Network information

Réf : IR.ER130

Re : **Evolution of the shunt park and harness on JSRC**

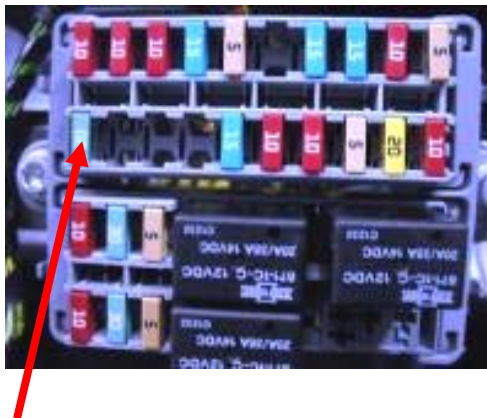
We inform you of an important evolution done on the vehicle JSRC Range with engine DCI, concerning the shunt park.

The shunt park is now situated on the fuse box. To change the position of the shunt park from park to use, you must change the position of the fuse of 30 A.

Park position

Use position

This evolution is effective starting from the following serial number:

| . JS RC moteur Dci | VH862-----1110966 |

Following to this modification, the spare part reference of passenger compartment and engine has changed :

| - Passenger compartment harness : | 1403946 |
| - Right engine harness : | 1403747 |
